Project	<b>IEEE 802.16 Broadband Wireless Access Working Group</b> < <a href="http://ieee802.org/16">http://ieee802.org/16</a> >
Title	<b>A method of scanning neighbor BSs periodically</b>
Date Submitted	<b>2004-06-07</b>
Source(s)	Kihyoung Cho, Yongho Kim, Chang jae Lee LG Electronics, Inc. 533, Hogye-1dong, Dongan-gu, Anyang-shi, Kyongki-do, Korea Voice: 82-31-450-2945 Fax: 82-31-450-7912 <a href="mailto:kihyoung@lge.com">[mailto:kihyoung@lge.com]</a> , <a href="mailto:ronnykim@lge.com">ronnykim@lge.com</a> , <a href="mailto:cjlee16@lge.com">cjlee16@lge.com</a> ]
Re:	This is a response to a Call for Comments IEEE802.16e Handover Adhoc.
Abstract	In this contribution, a method of supporting periodic scanning is provided.
Purpose	This document is submitted for review by 802.16e Working Group members
Notice	This document has been prepared to assist IEEE 802.16. It is offered as a basis for discussion and is not binding on the contributing individual(s) or organization(s). The material in this document is subject to change in form and content after further study. The contributor(s) reserve(s) the right to add, amend or withdraw material contained herein.

# A method of scanning neighb

**Figure E.1—Example BS advertisement and scanning (without association) by MSS request**

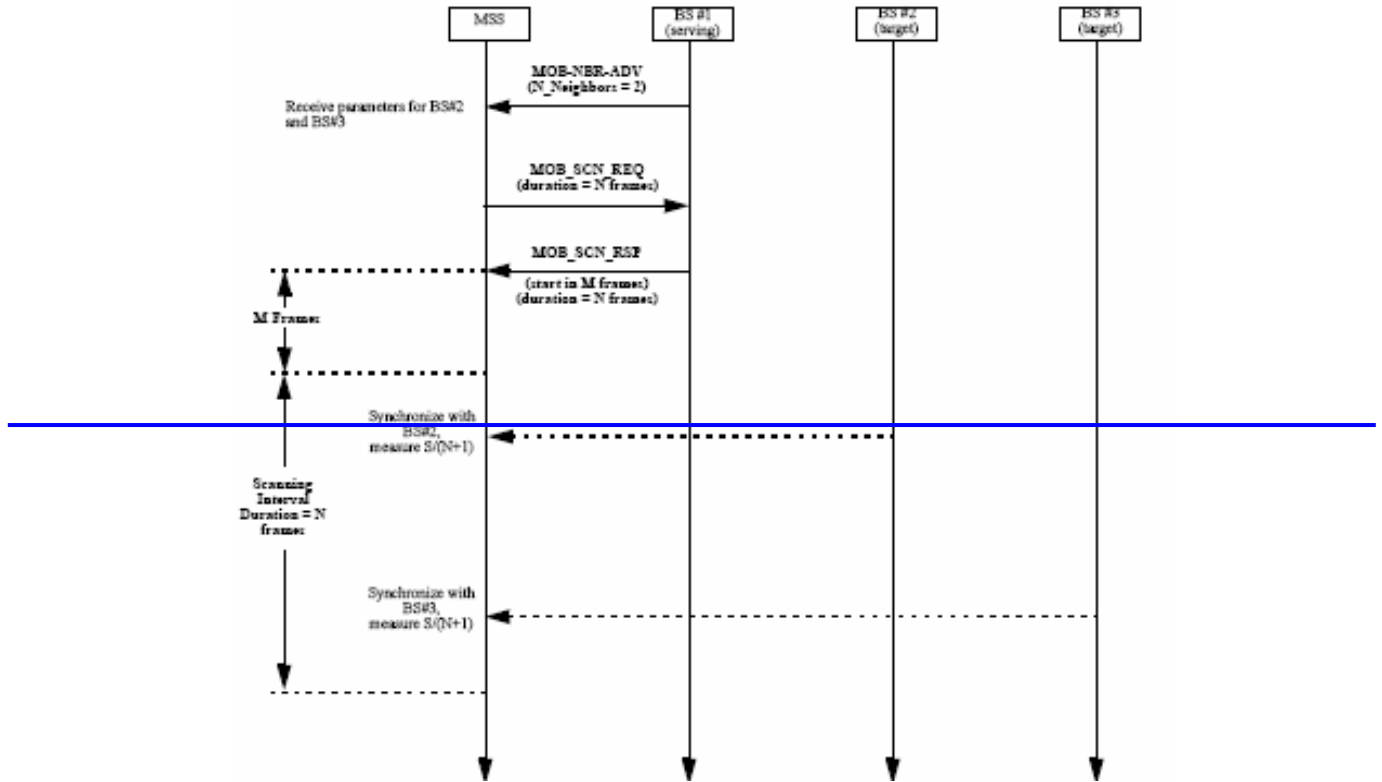
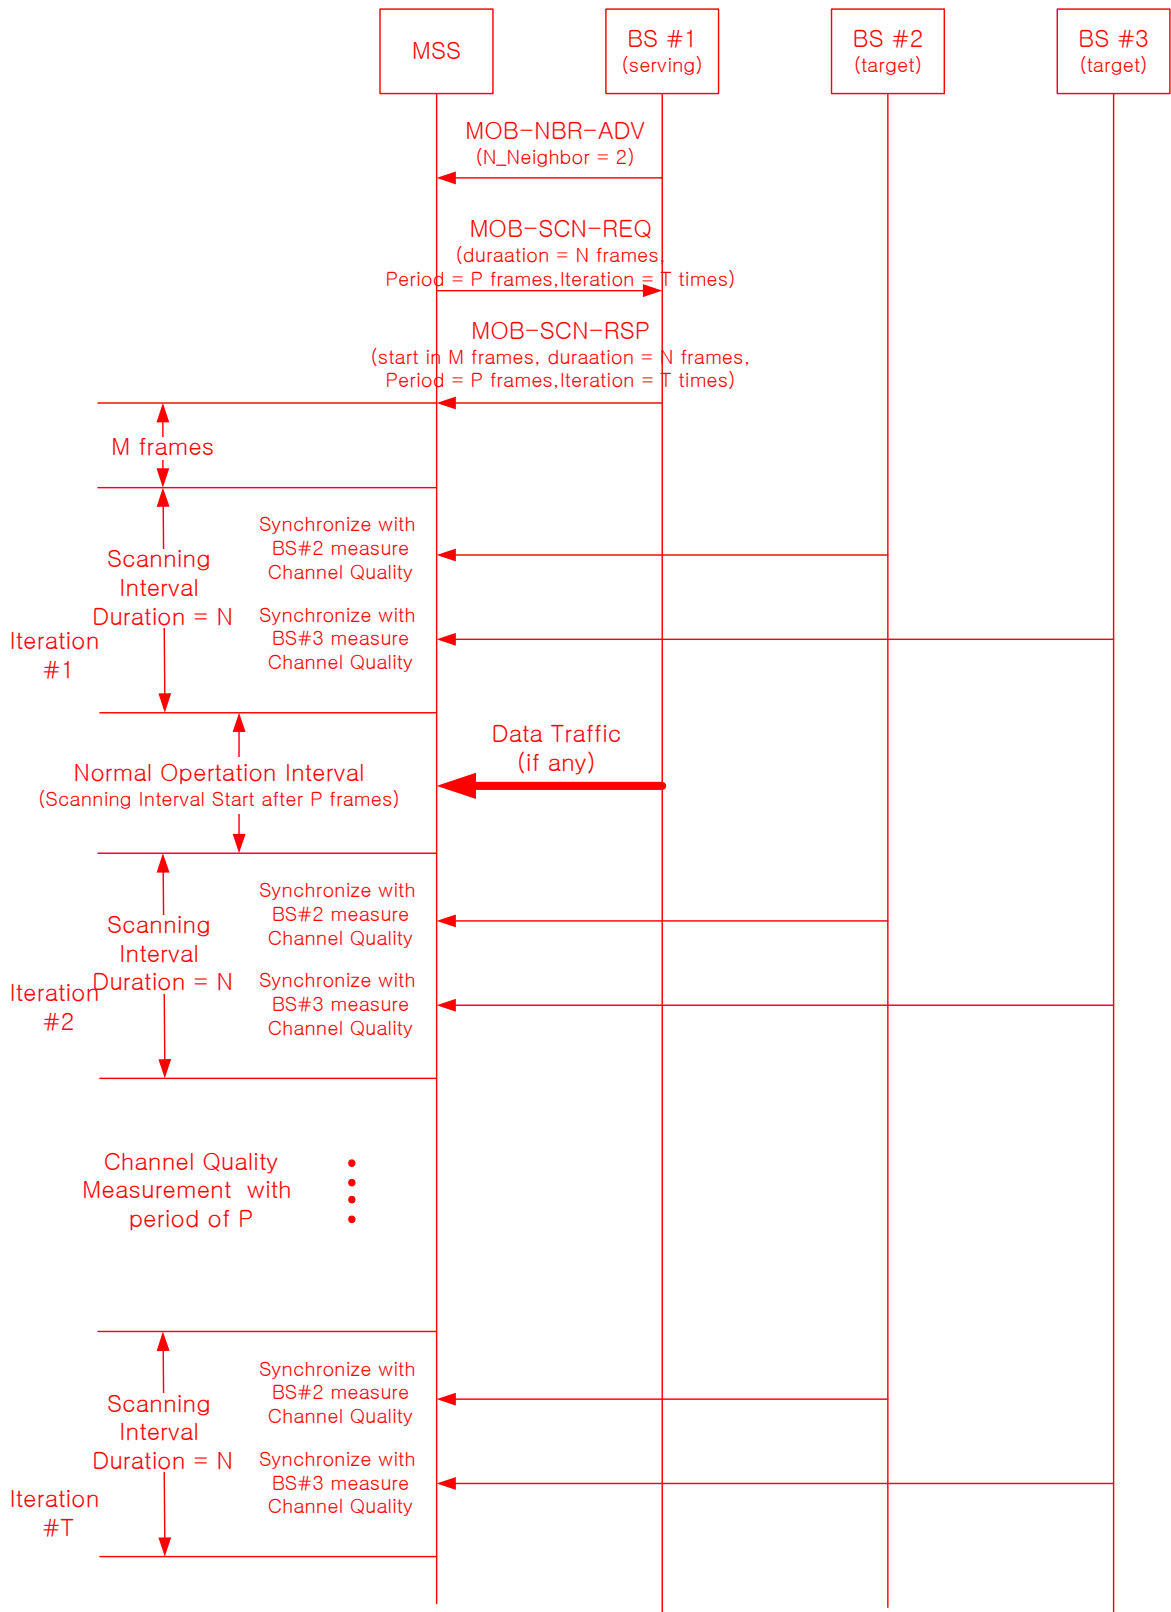
*[Modify the Figure E.1– Example BS advertisement and scanning (without association) by MSS request]*

The following figures describes the messages flow for neighbors advertisement and scanning of neighbors by the MSS request, BS request and periodic scanning of neighbors during hand-over.
